IDAS1125620 DA2020/468 CNR-8629 A-9815

Re: Advice only

I refer to your proposed concept for 51 Station Lane Lochinvar 3/DP564631, 134 Station Lane Lochinvar 4/DP634523, 146 Station Lane Lochinvar 2/DP634523 (Part)

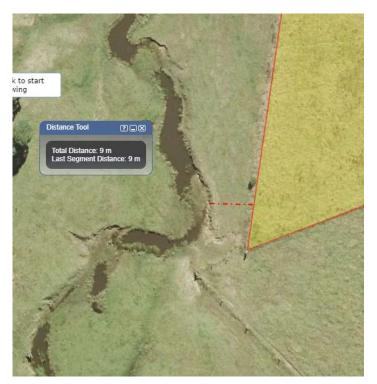
3. . This area (circled) is too close to the  $3^{\rm rd}$  watercourse for this detention basin to be in its current position. It should be 15m away.
